General Building Permit Application

INTERIOR TENANT FIT-UP FOR:
OFFICE TENANT
SUITE 1 & 2
15 MIDDLE STREET
PORTLAND, MAINE 04101

PROPOSED PLANS

Jeanie Bourke - RE: 22 Hancock St., BP#2014-02364 (15 Middle)

1ST FLOOR PLAN

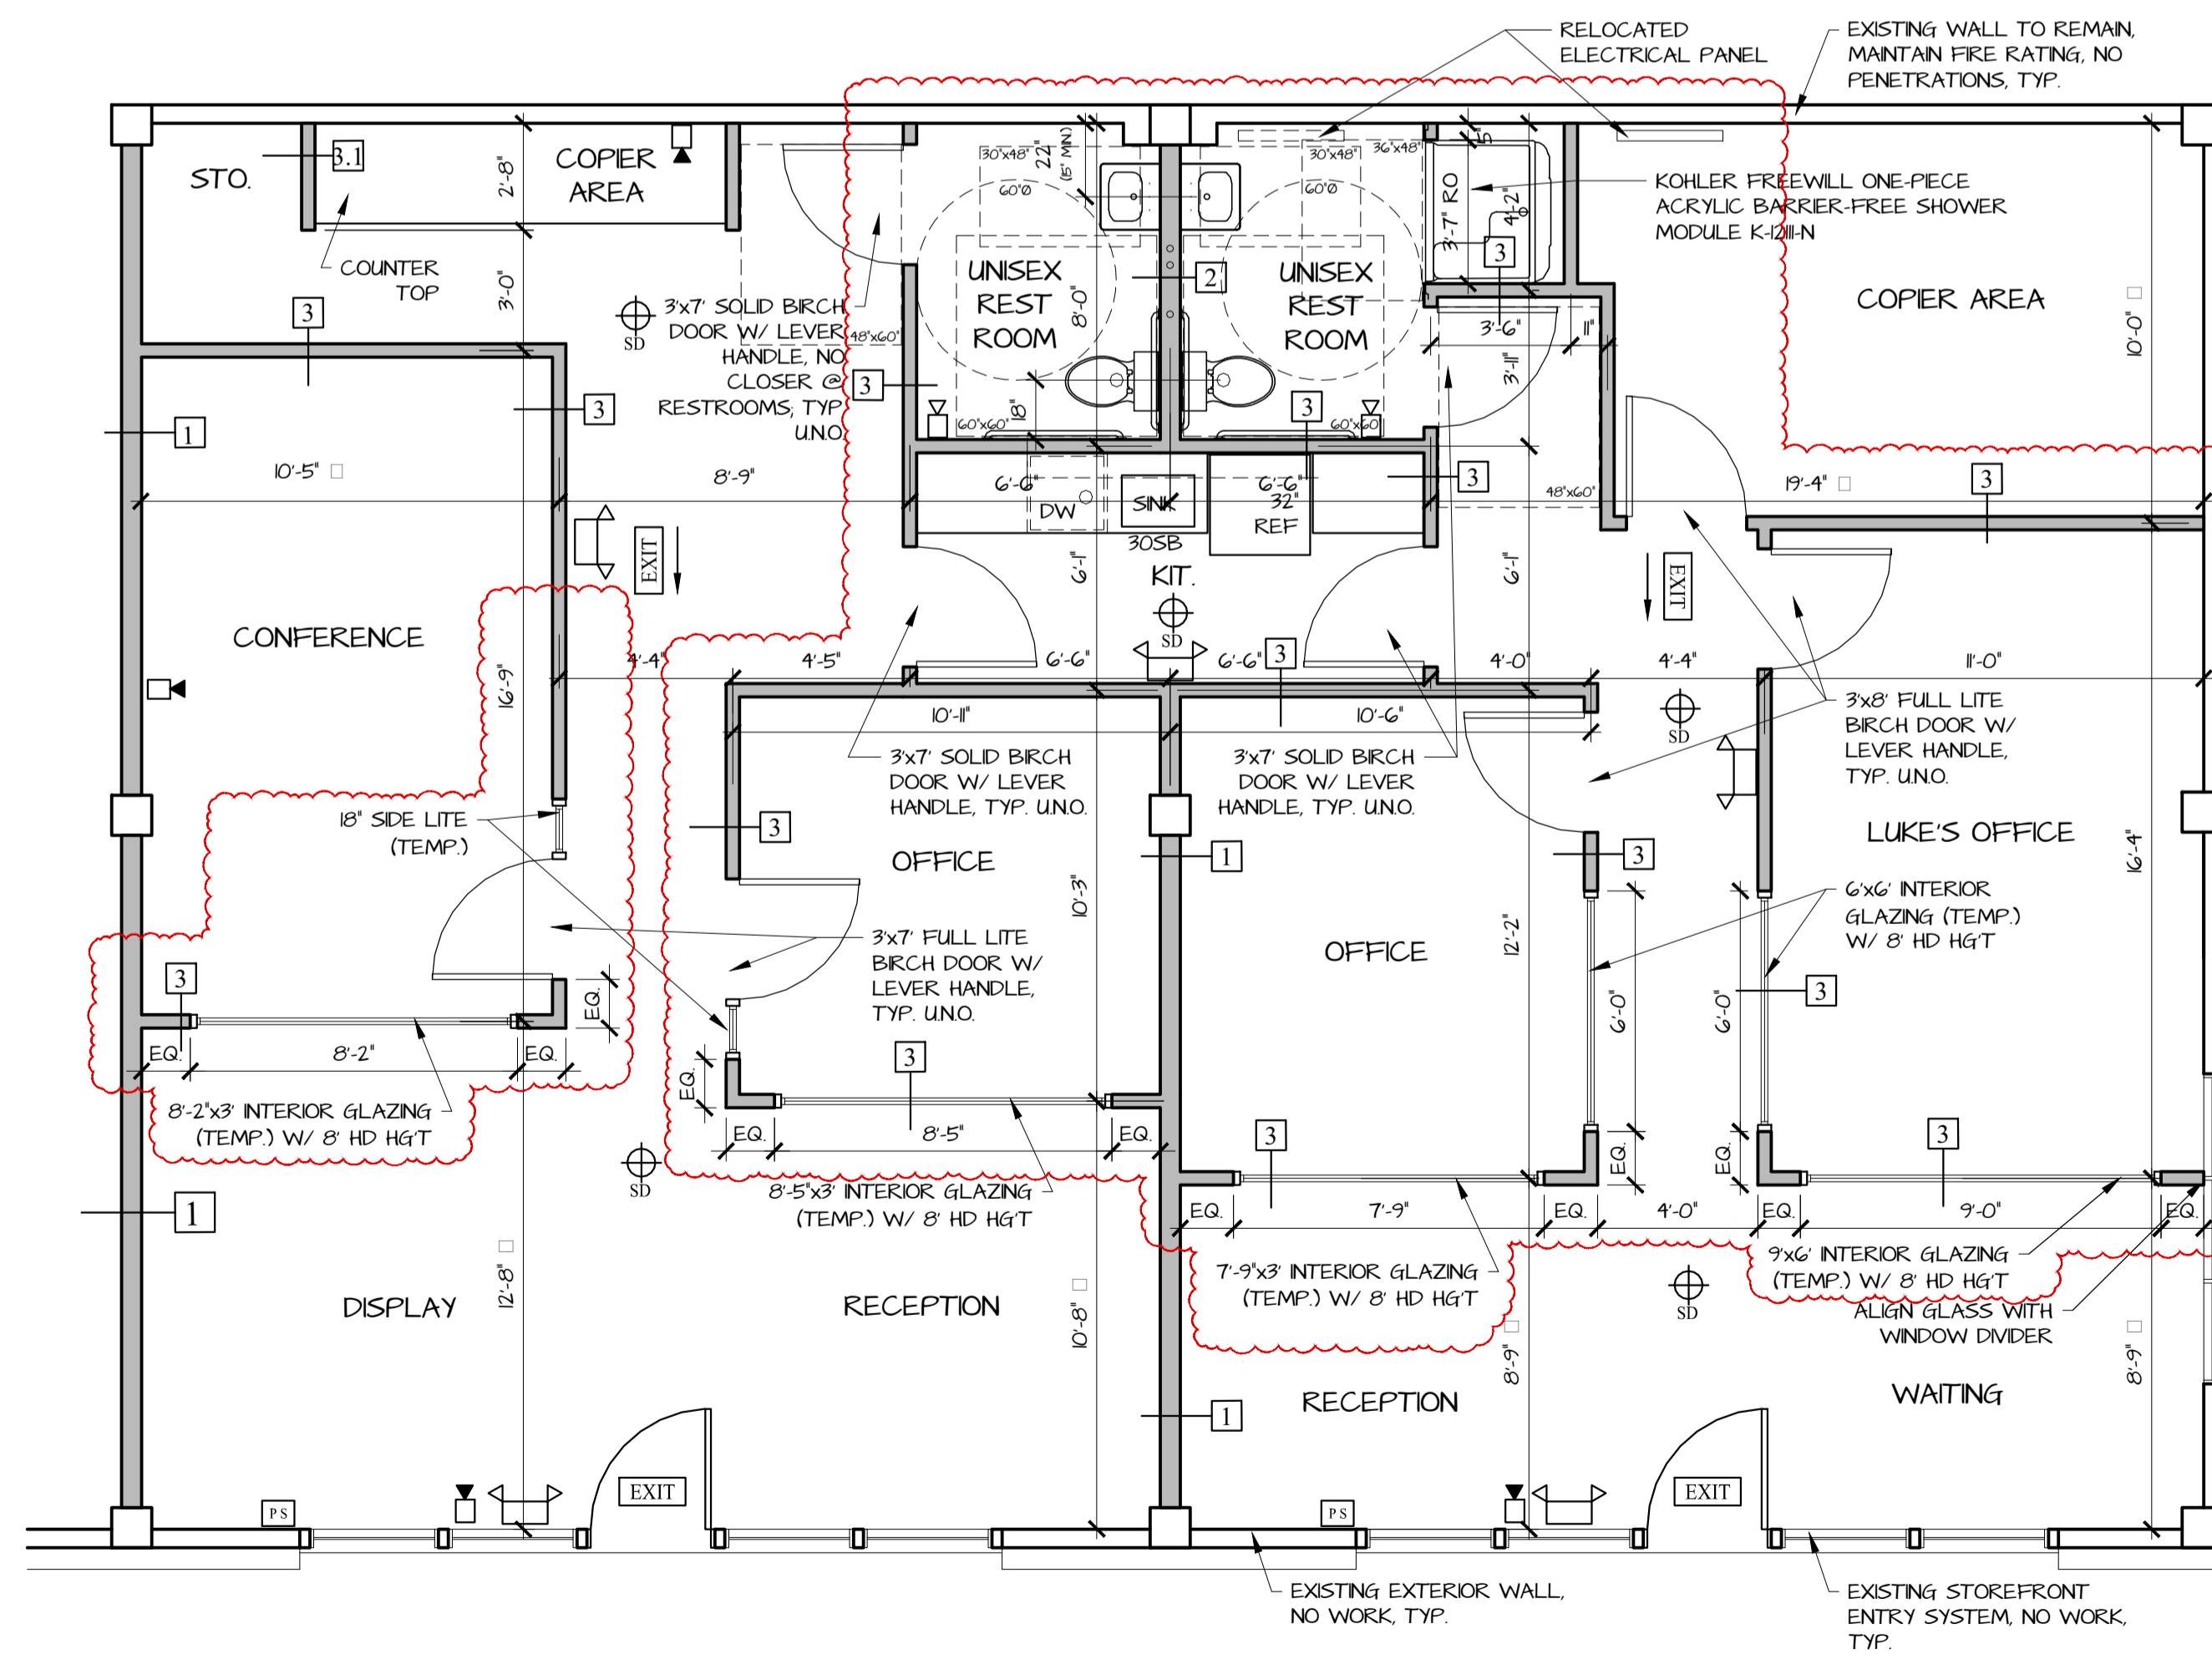
You applied for this under 15 Middle, however if you look closer, on the Assessors GIS map, you will see the work is being done in 22 Hancock.

1. The plan does not show any wall demo, was this a vanilla box, or are there existing tenant or condo demising walls? If so, the plan should reflect this, as 2 condos are merging. **There are currently no walls existing at any of the 3 spaces. The condos are staying as two separate entities purchased by one buyer; this would not be a merger. The spaces simply share a kitchenette.**
2. What is the ceiling design? Do you have a RCP, or is it all ACT? **We have not put together a RCP as it will all be suspended acoustical ceiling tiles...design build with lighting and HVAC.**
